SUBJECT: VIRGIL C. SUMMER NUCLEAR STATION, UNIT 1 - STAFF ASSESSMENT OF
RESPONSE TO 10 CFR 50.54(f) INFORMATION REQUEST – FLOOD-
CAUSING MECHANISM REEVALUATION (TAC NO. MF1112)

STAFF ASSESSMENT BY THE OFFICE OF NUCLEAR REACTOR REGULATION

RELATED TO FLOODING HAZARD REEVALUATION REPORT

VIRGIL C. SUMMER NUCLEAR STATION, UNIT 1

Figure 3.3-2. Service Water Pond and Monticello Reservoir

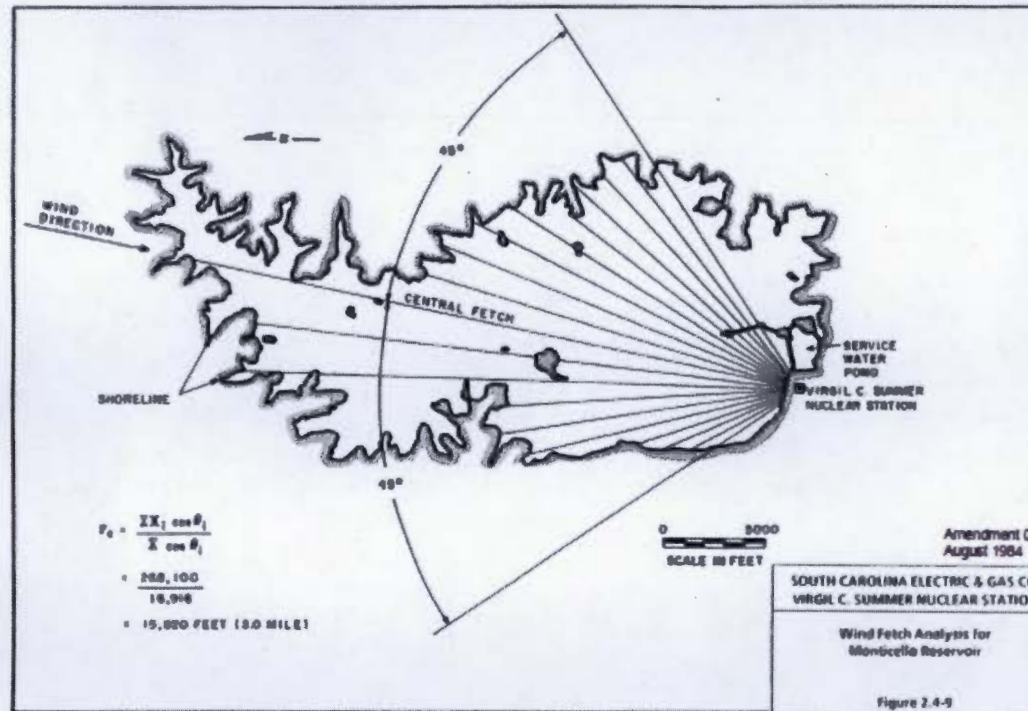
The staff reviewed the licensee's description of its Monticello Reservoir drainage area PMF calculation in the FHRR (SCE&G, 2013a). Given the significant role that the Monticello Reservoir plays in the licensee's analysis of the PMF from rivers and streams, and the need to review the formulation of the model's complex spatially, and temporally distributed input, the staff requested that the licensee provide a detailed description of the analysis it completed to support its conclusions. The licensee provided a detailed description of the PMF estimation in the Monticello Reservoir drainage area (SCE&G, 2014b, RAI 3 response). The licensee described the process by which the 72-h PMP depth of 47.7 in (121 cm) was determined to result in an estimated maximum water-surface elevation in Monticello Reservoir at the North Berm of 437.0 ft (133.2 m) when wave action is considered (SCE&G, 2013a).⁸ All of these water surface elevations are below the 438.0 ft (133.5 m) crest elevation of the North Berm (See Figure 3.3-2).

In the VCSNS, Unit 1 FHRR (SCE&G, 2013a), the SWP is described as a Seismic Category 1 impoundment that serves as the Ultimate Heat Sink for VCSNS, Unit 1. The SWP is adjacent to Monticello Reservoir (Figure 3.3-2). The SWP is separated from Monticello Reservoir by two islands and three Seismic Category 1 dams, which have crest elevations of 438.0 ft (133.5 m) on three sides. The crest elevation of the West Embankment is 435.0 ft (132.6 m). The West Embankment adjoins the VCSNS, Unit 1 plant yard grade, and therefore represents the land elevation value critical for assessment of the PMF maximum water-surface elevation in the SWP.
